0	ISSUED FOR ADDENDUM	01/20 2021
revisions		date
project		projet

**AAFC RESEARCH AND  
DEVELOPMENT CENTRE  
OUTBUILDINGS RENOVATIONS**

**BUILDING 11  
FIRST FLOOR AND ATTIC  
PLAN  
MODIFICATIONS  
VENTILATION**

Tender	Soumission
PWGSC Project Manager	Administrateur de projets TPSGC
project number	no. du projet
	<b>R.106530.003</b>
drawing no.	no. du dessin
	<b>SKM-1</b>

BUILDING 11 – PARTIAL FIRST FLOOR – VENTILATION MODIFICATIONS

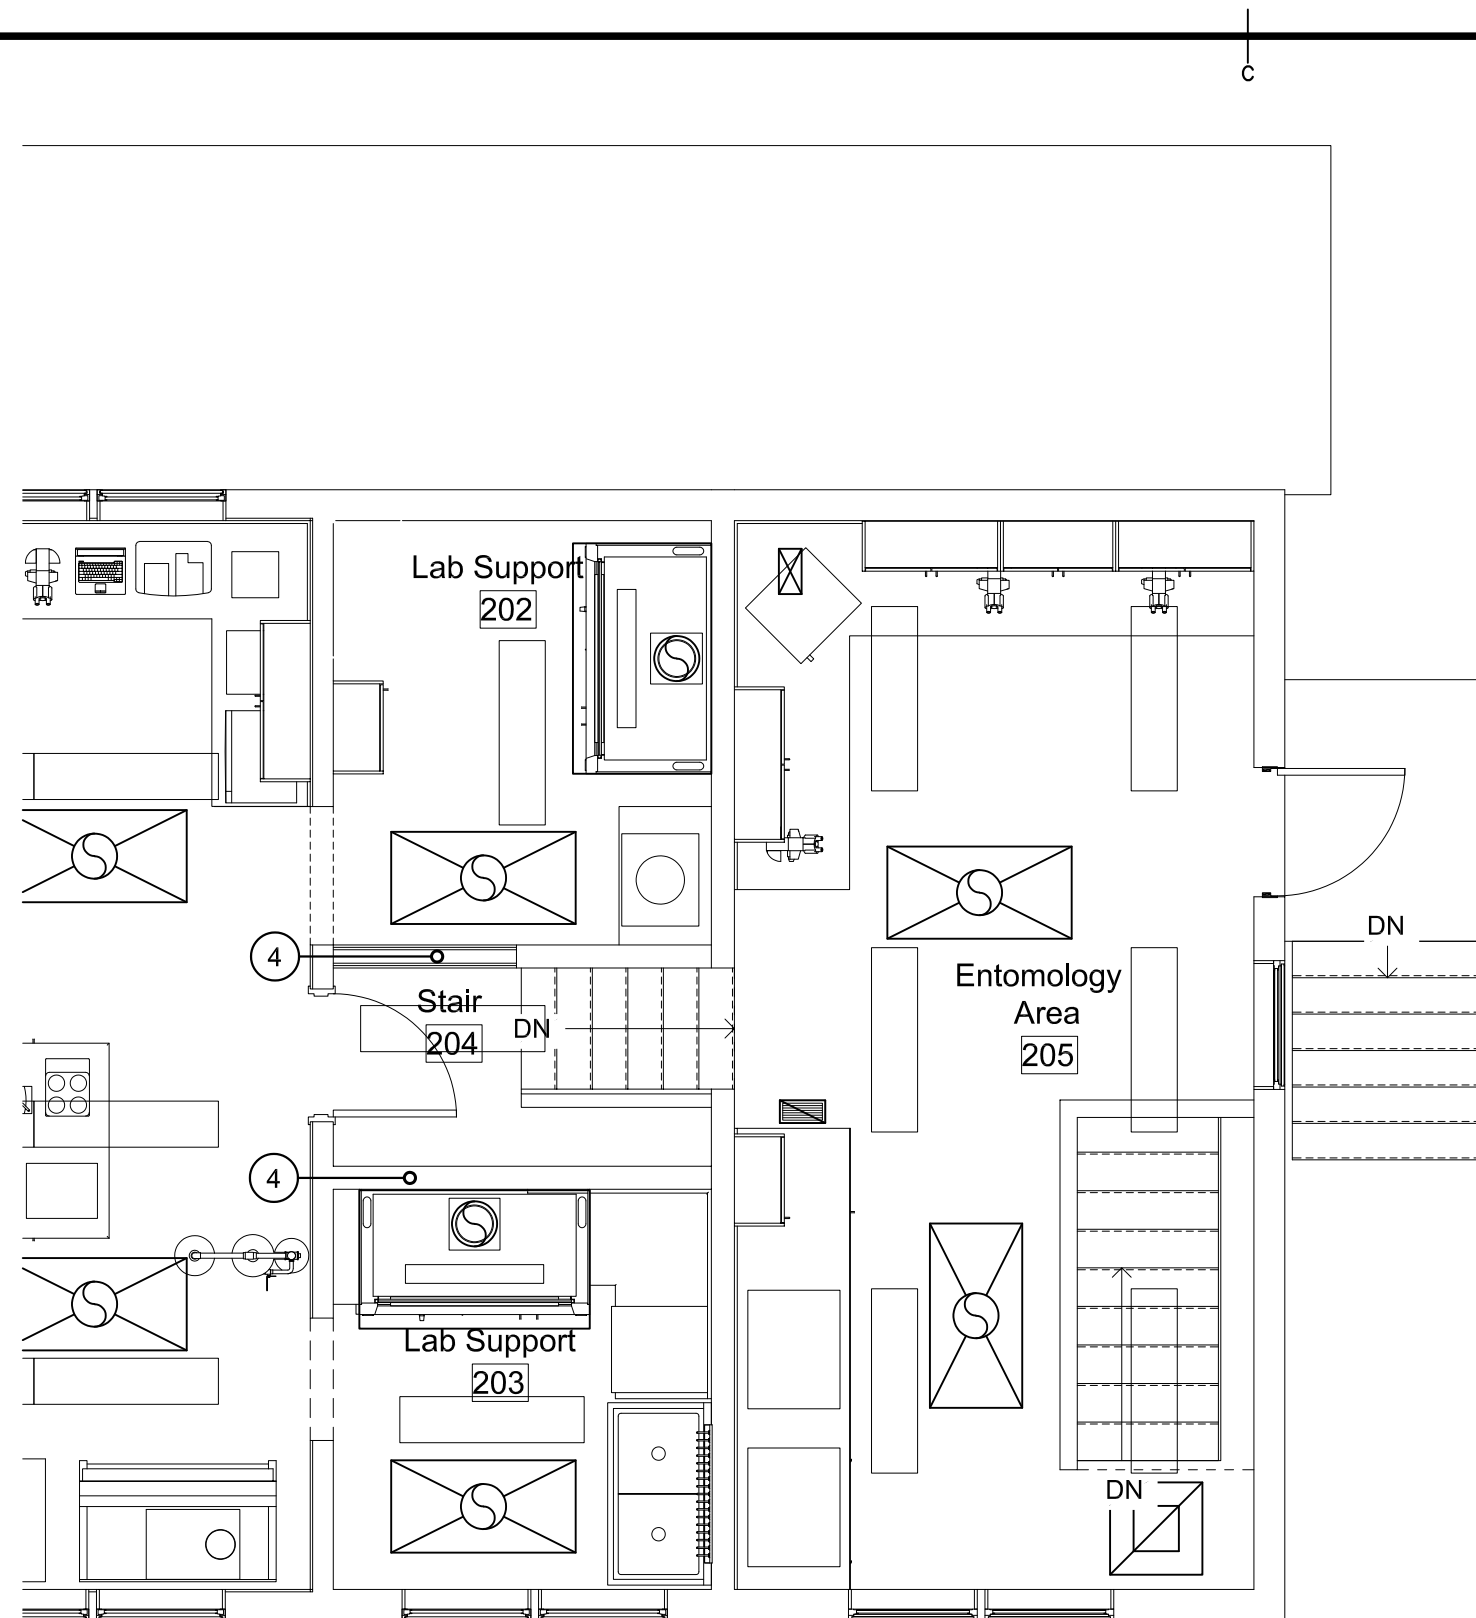
75mmØ FRPP  
POLYPROPYLENE SCHEDULE  
80 PIPING TO CONNECT TO  
FUME HOOD CHEMICAL  
STORAGE UNDER HOOD.  
CONNECT TO EXISTING VENT  
LINE INTEGRAL TO FUME  
HOOD. CAP REMAINING PIPE.  
PIPING TO BE TO ASTM D4104  
C/W ELECTROFUSION  
FITTING. FAN TO RUN  
CONTINUOUSLY. CONTROLS  
TO PROVIDE START/STOP  
AND STATUS.

**BUILDING 11 – PARTIAL ATTIC PLAN – VENTILATION MODIFICATIONS**

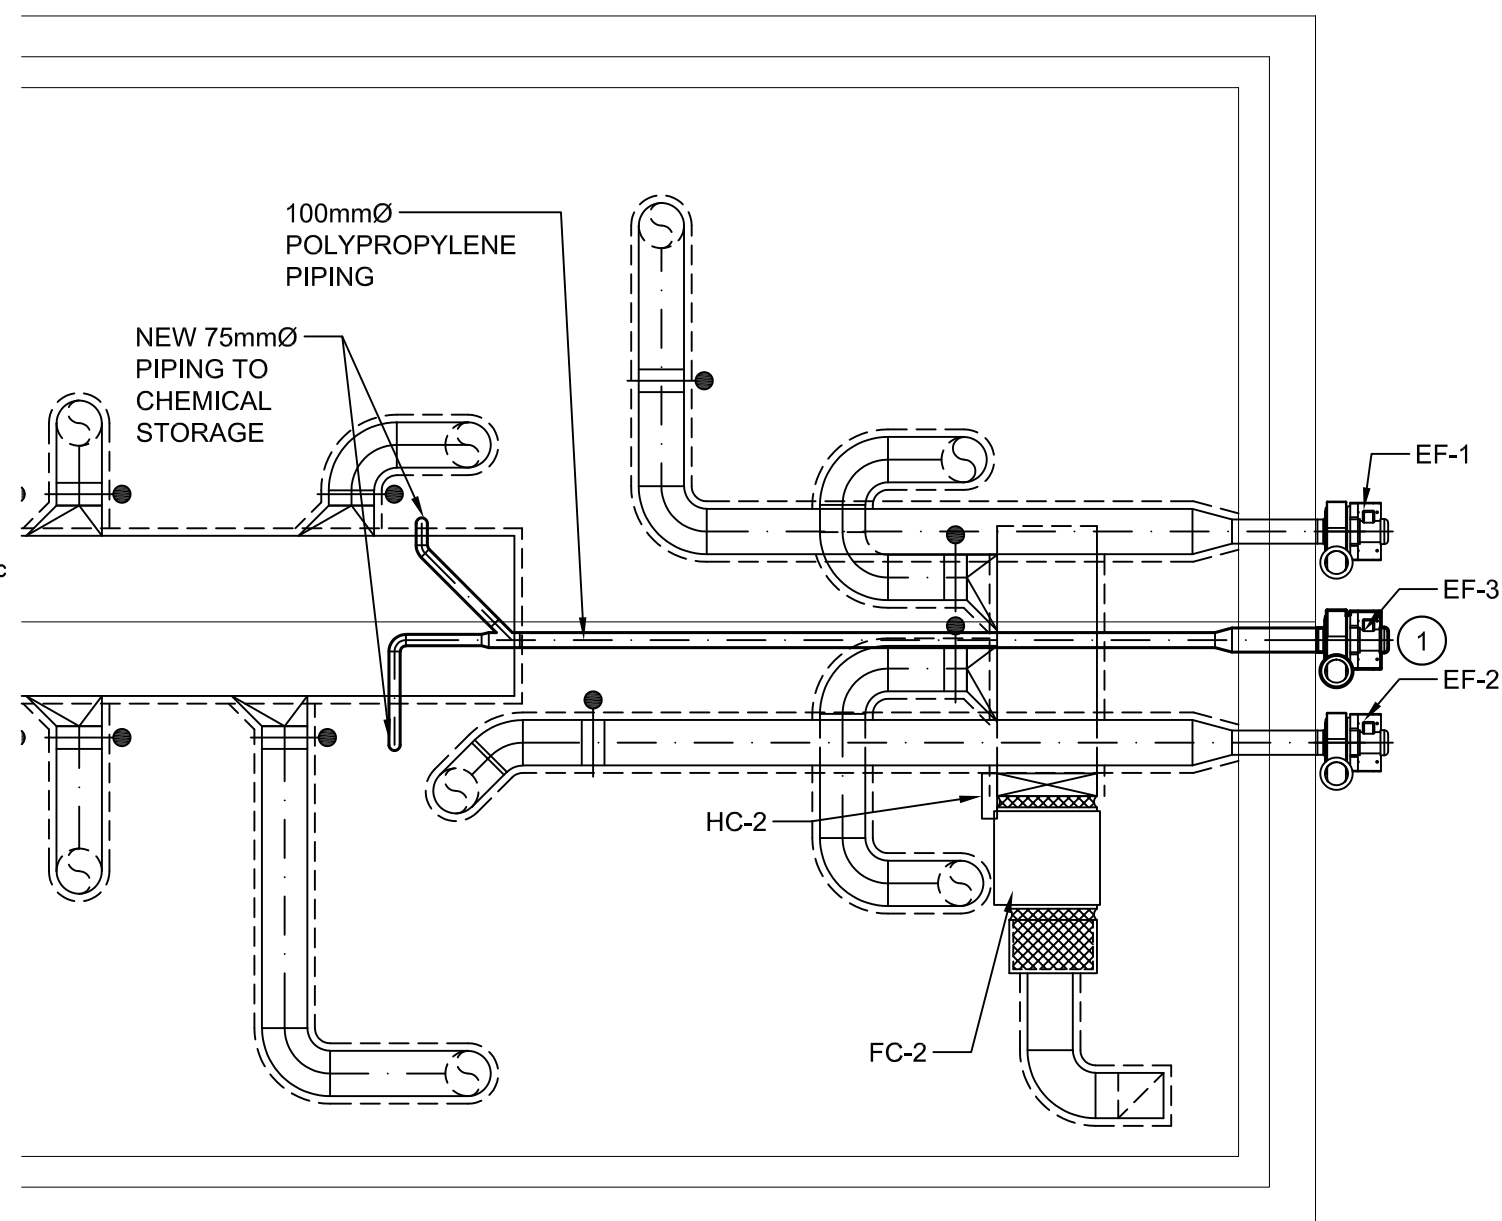
1. ALL DUCTWORK WITHIN ATTIC SPACE TO BE INSULATED.

- 1 NEW CHEMICAL STORAGE FAN TO BE SUPPLIED AND INSTALLED BY VENTILATION CONTRACTOR. FOR INSTALLATION DETAILS, REFER TO

6  
M-5
